MAJOR ALTERATIONS + ADDITIONS TO
THE STEVENSON LIBRARY (SSD 8922)

S4.55 Modification Application

S4.55-2 MODIFICATION APPLICATION

1 Proposed Fifth Floor Plan RL 71.05
Scale: 1:200

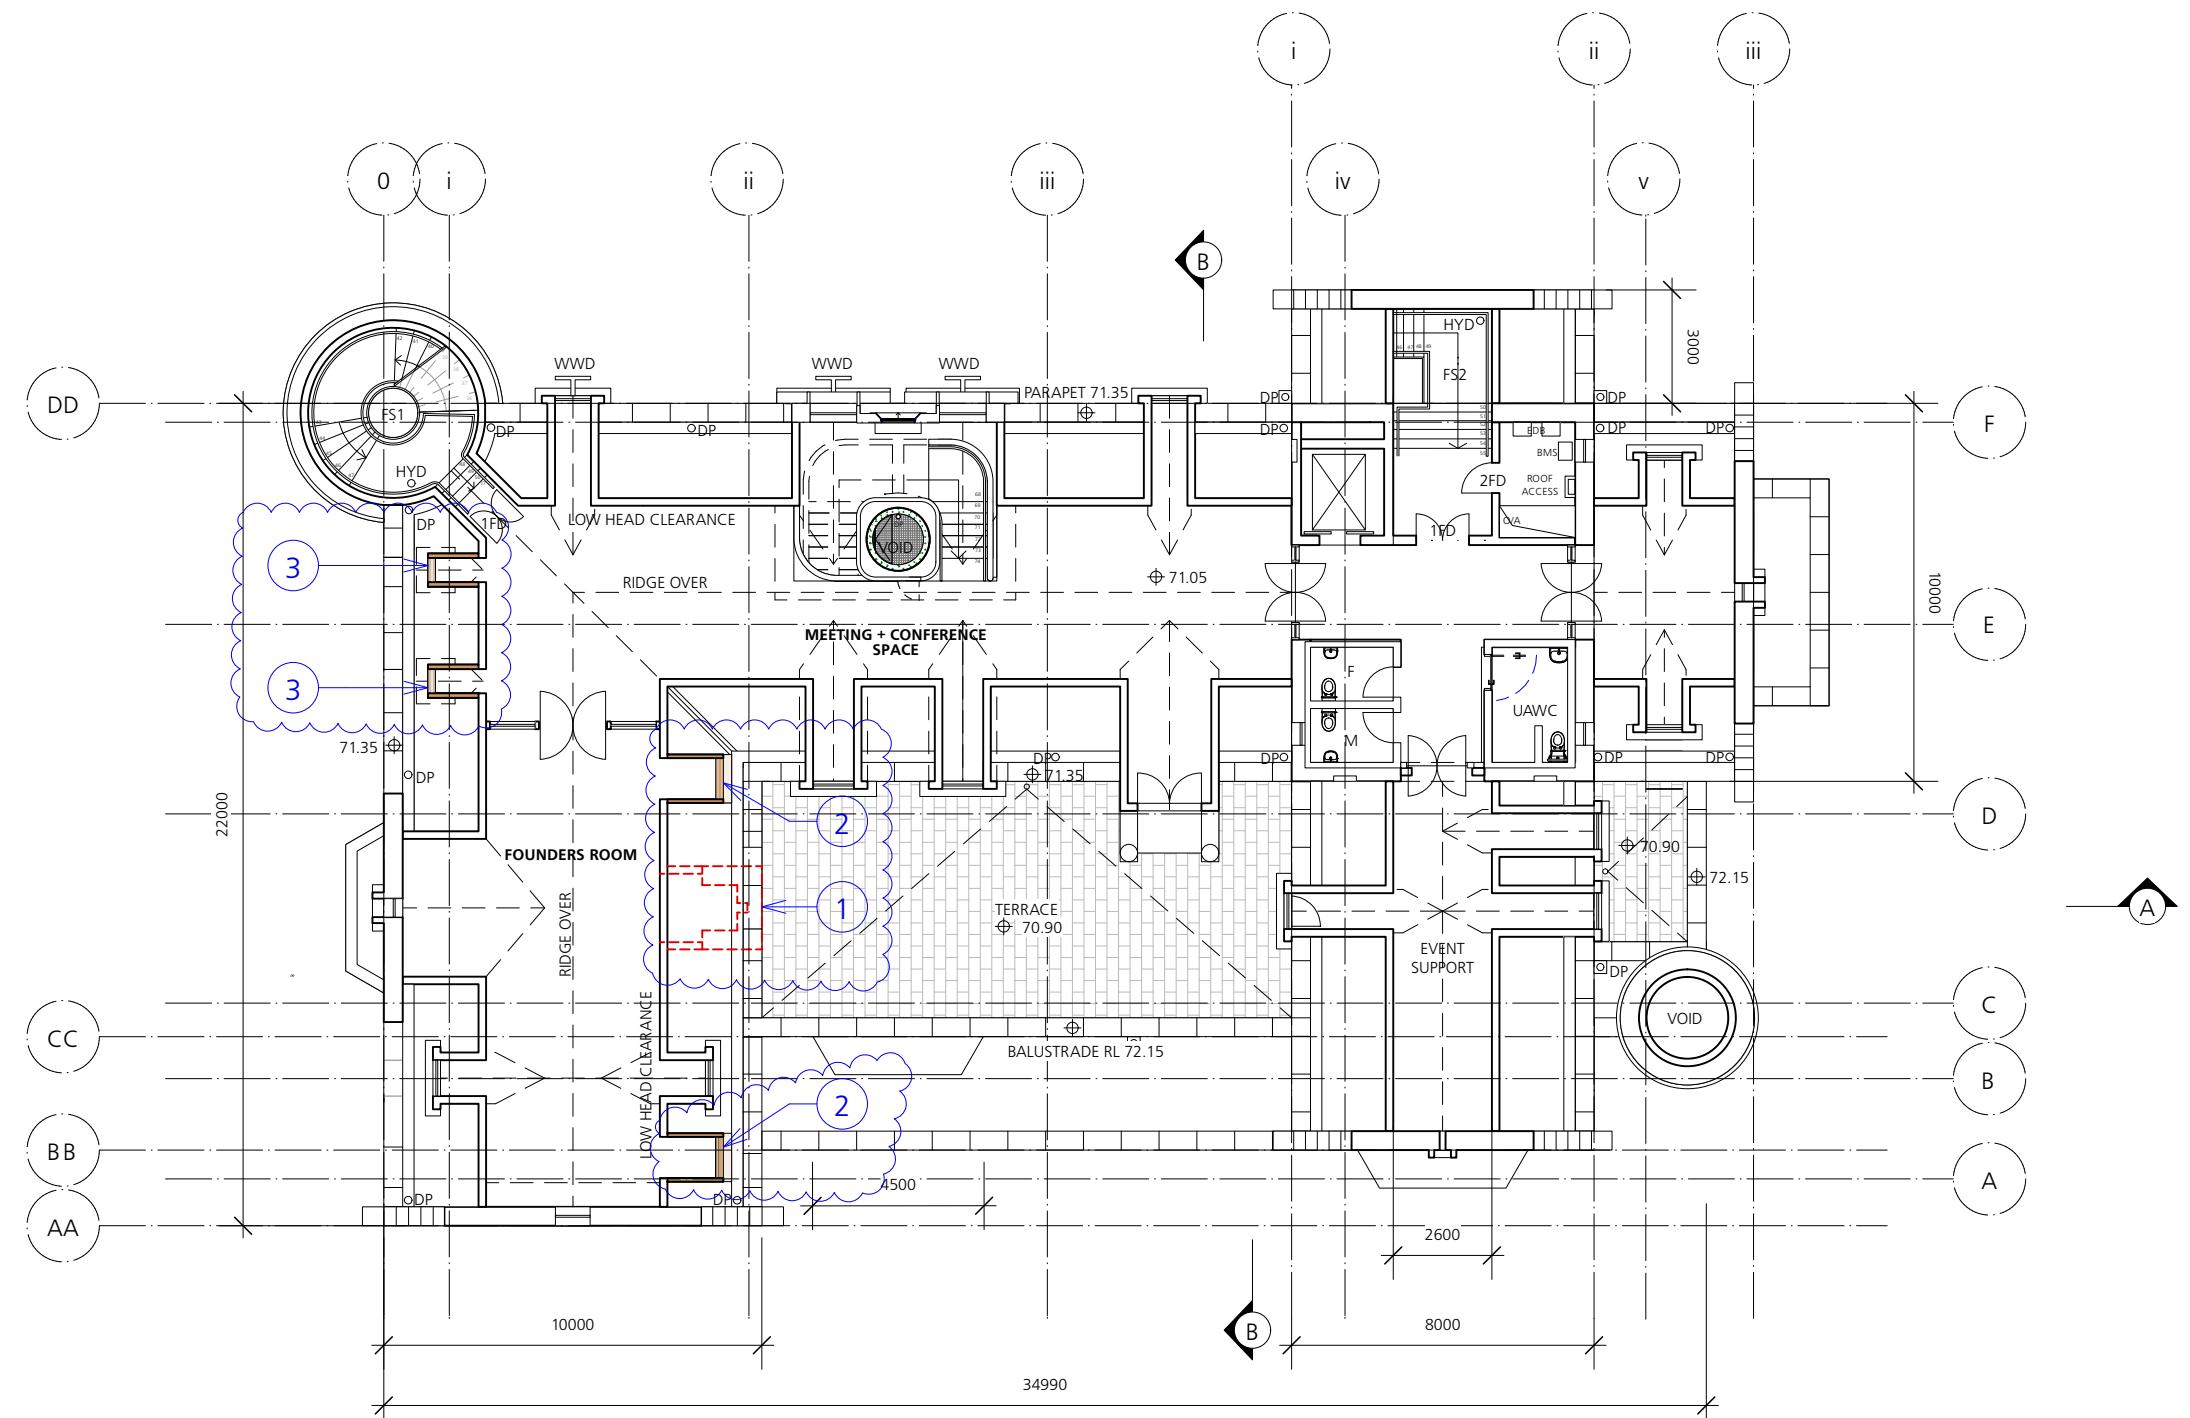
1. CHIMNEY DELETED.
2. TWO FRESH AIR LOUVRES ADDED.
3. REDUCED PROFILE OF TWO DORMERS TO SOUTHERN FACADE
4. RIDGE CREST DELETED.

1 Proposed Roof Plan RL 75.25
Scale: 1:200

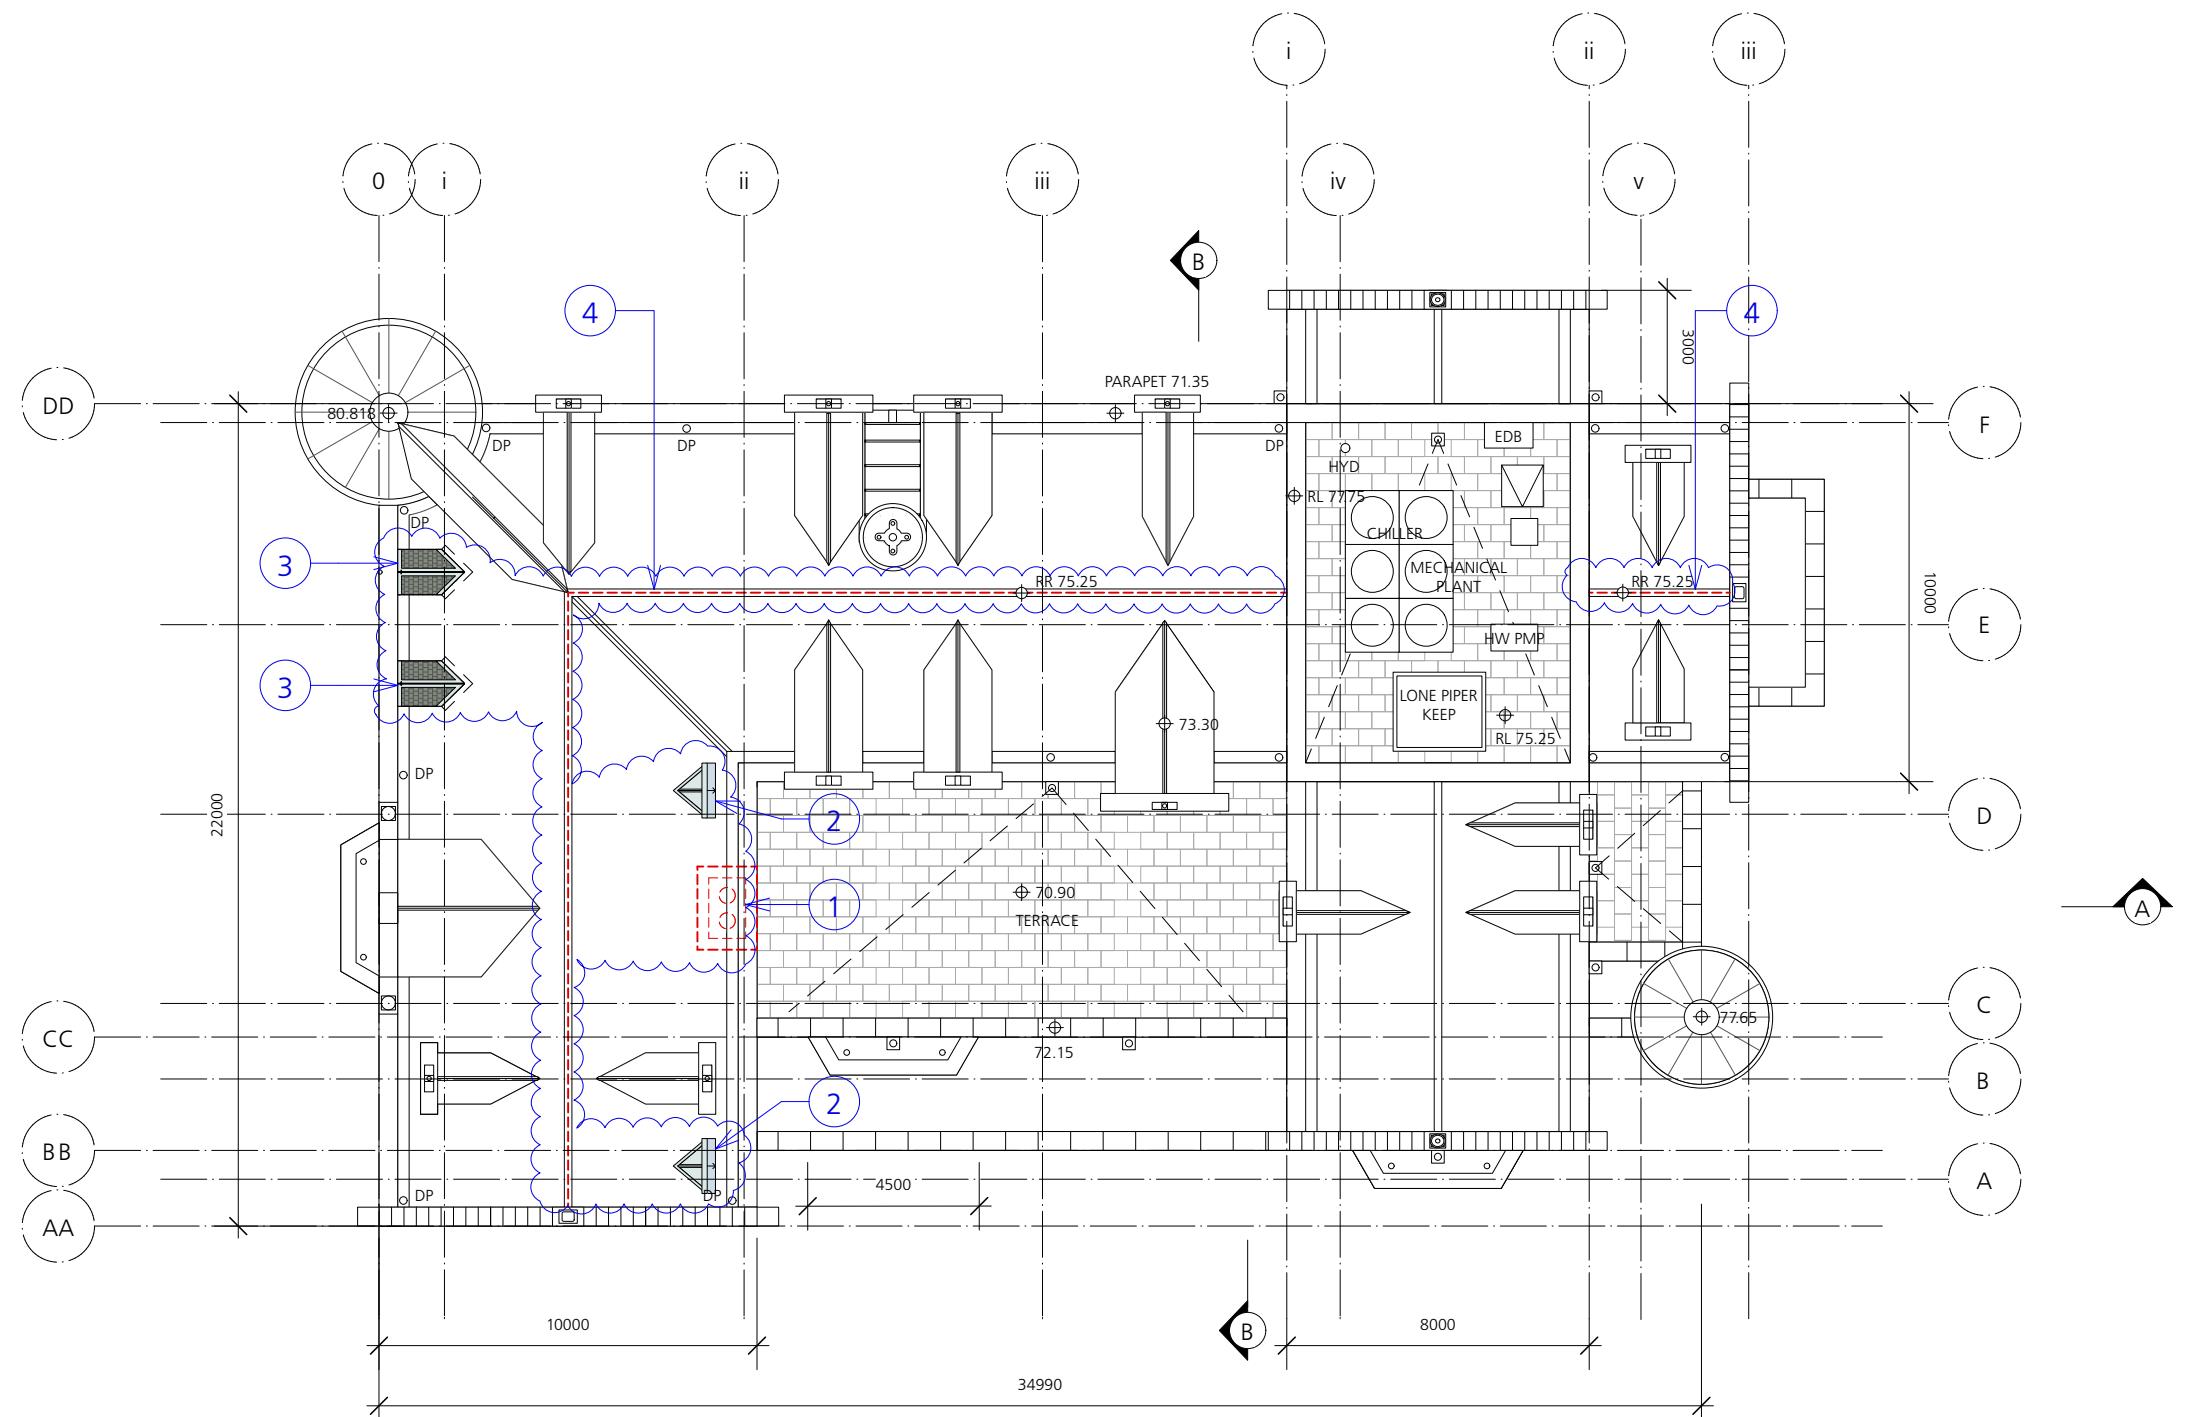
1. CHIMNEY DELETED.
2. TWO FRESH AIR LOUVRES ADDED.
3. REDUCED PROFILE OF TWO DORMERS TO SOUTHERN FAÇADE
4. RIDGE CREST DELETED.

1 SSD Proposed Northern Elevation
Scale: 1:200

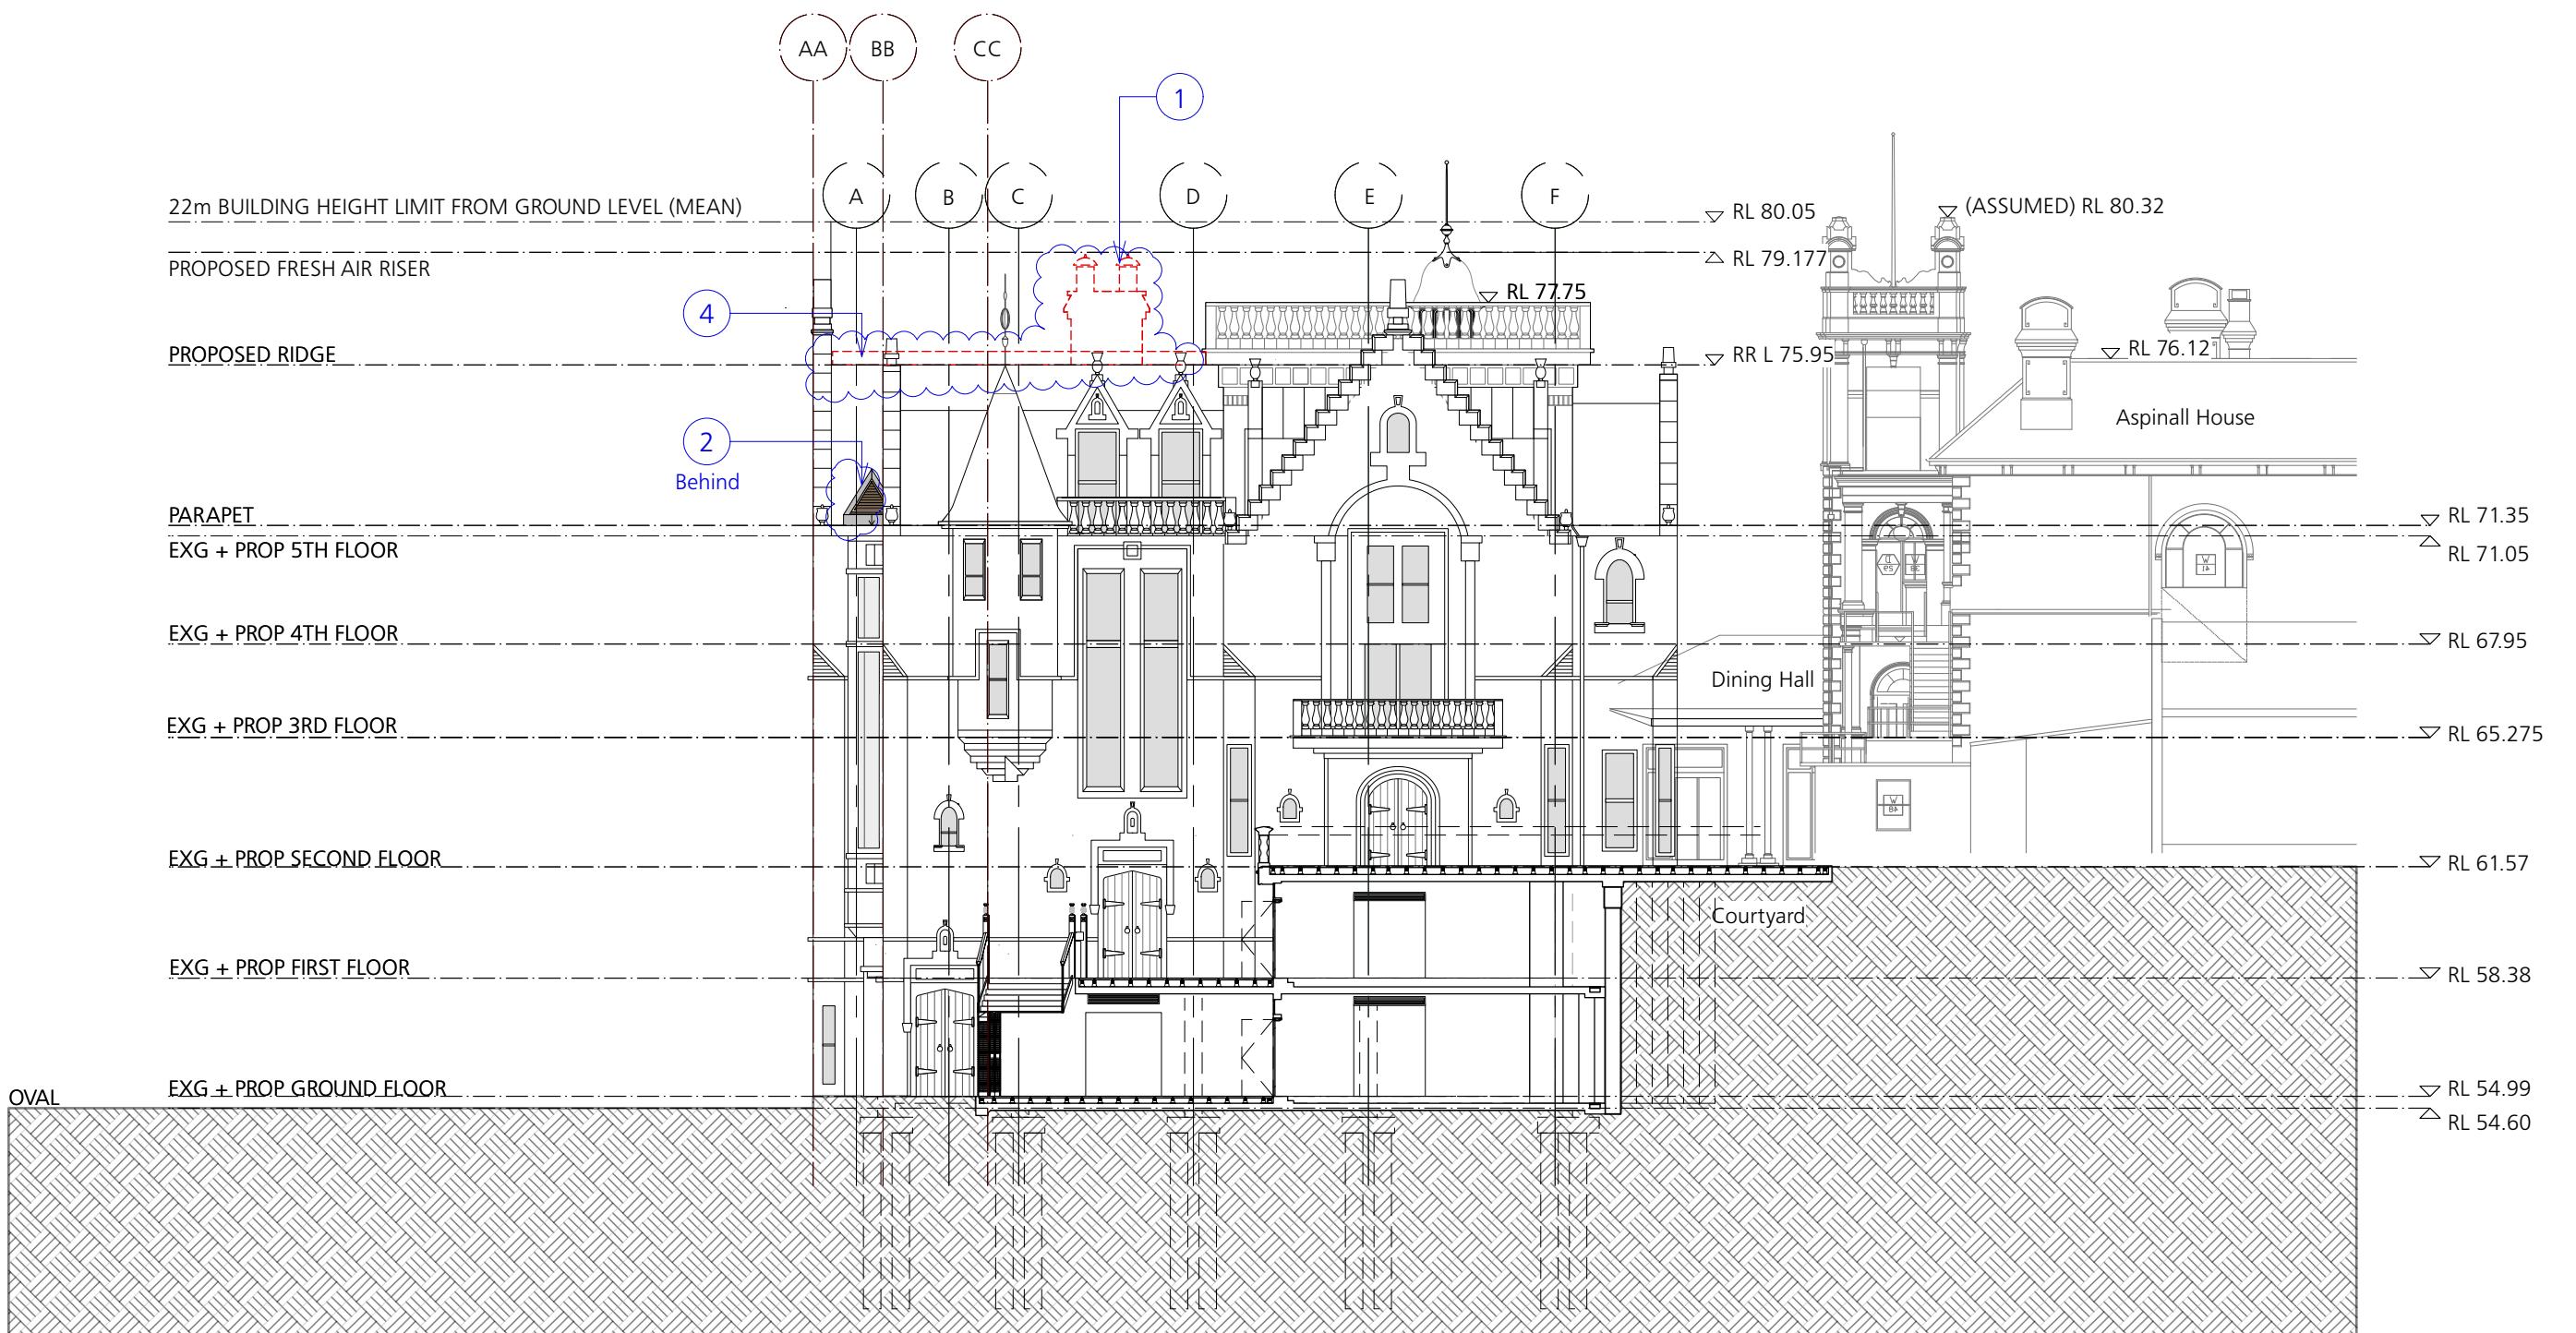
1. CHIMNEY DELETED.
2. TWO FRESH AIR LOUVRES ADDED.
3. REDUCED PROFILE OF TWO DORMERS TO SOUTHERN FAÇADE
4. RIDGE CREST DELETED.
